Application No.	DA/2023/0753			
Address	84 Albion Street ANNANDALE			
Proposal	Alterations to existing dwelling and construction of a double			
Toposa	garage and gym over at rear of site			
Date of Lodgement	18 September 2023			
Applicant	Mr Hong H Ko			
Owner	Mr Anthony M McClenaghan			
Owner	Mr Hong H Ko			
Number of Submissions	Initial: 0			
Cost of works	\$255,000.00			
Reason for determination	Clause 4.6 variations exceed 10% (FSR)			
at Planning Panel				
Main Issues	Departure from Floor Space Ratio and Site Coverage			
	development standard			
Recommendation	Approved with Conditions			
Attachment A	Recommended conditions of consent			
Attachment B	Plans of proposed development			
Attachment C	Section 4.6 Exception to Development Standards - FSR			
Attachment D	Section 4.6 Exception to Development Standards –			
	Site Coverage			
Attachment E	Statement of Heritage Significance			
Attachment E Statement of Heritage Significance

1. Executive Summary

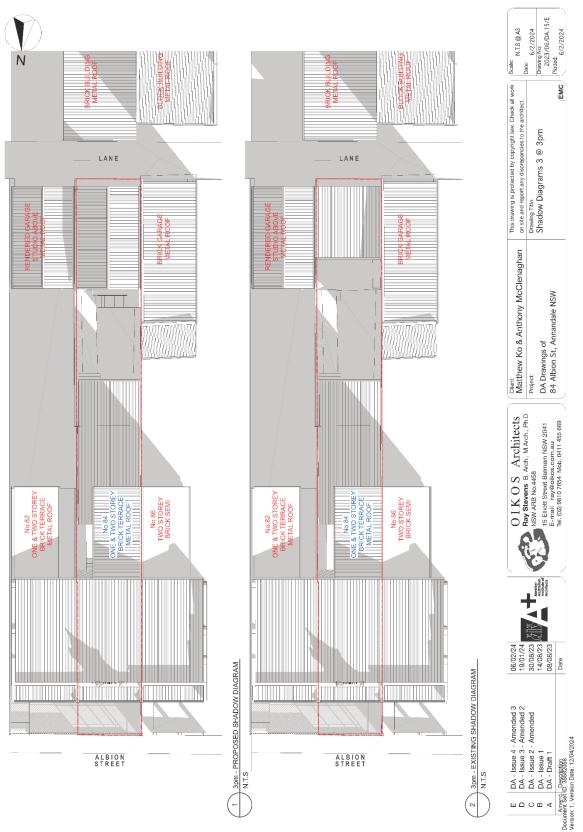
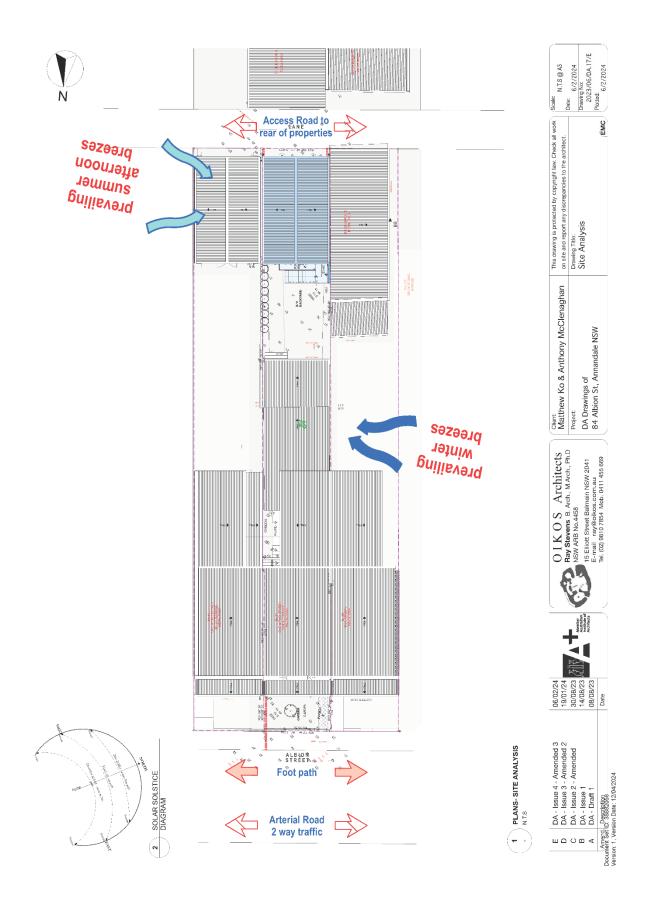
a. The windows in the rear façade of the gym facing the lane are to be of a traditional material (timber frame) b. The erection of privacy screens having a minimum block out density of 75% and a height of 1.6 metres above the finished floor level of the deck on the eastern side of the elevated landing and deck servicing the proposed first floor gym/studio specifically adjoining (i) The landing area adjoining step 10 marked on plans DA.06.E at R 23.44; and (ii) The balustrade adjacent to the bifold doors with a deck RL of 23.62
	Reason: To ensure the finishes compliment the conservation area and that visua privacy treatment protects the amenity of the neighbourhood.
